MURRAY BRIGHAM PLACE SUBDIVISION

APPLICATION NUMBER 3 DATE May 7, 2009

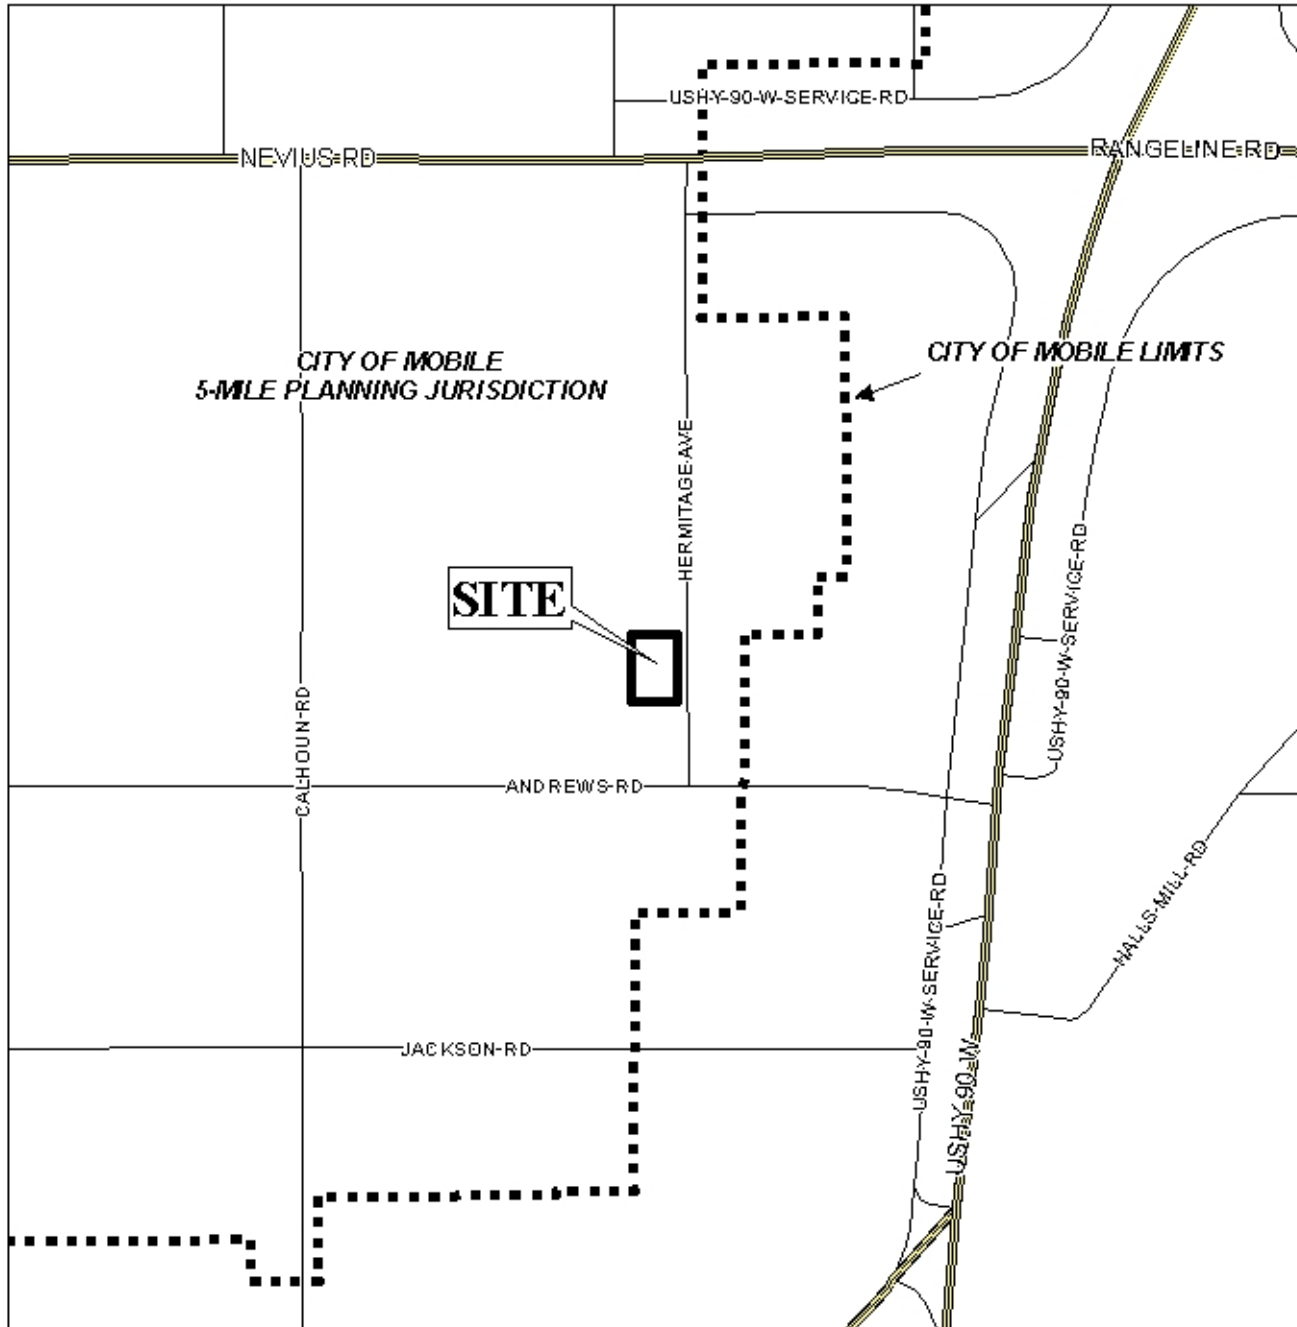
- 1) the inclusion of the remainder of Lot 23 Block 2 of Suburban Gardens with the applicable labels and fees or the submission of the deed illustrating that the subdivision or parceling off was created prior to 1984;

- 2) provision of a note on the Final Plat stating that each lot is limited to one curb cut for each lot;
- 3) provision of a note on the Final Plat stating that any lots which are developed commercially and adjoin residentially developed property must provide a buffer, in compliance with Section V.A.7. of the Subdivision Regulations;

- 4) Placement of a note on the site plan stating that the site must be developed in compliance with all local, state and Federal regulations regarding endangered, threatened or otherwise protected species;

- 5) provision of a note on the Final Plat stating that the development will be designed to comply with the storm water detention and drainage facility requirements of the City of Mobile storm water and flood control ordinances, and requiring submission of certification from a licensed engineer certifying that the design complies with the storm water detention and drainage facility requirements of the City of Mobile storm water and flood control ordinances prior to the issuance of any permits. Certification is to be submitted to the Planning Section of Urban Development and County Engineering; and

- 6) labeling on the Final Plat of each lot in square feet, or provision of a table with the same information.
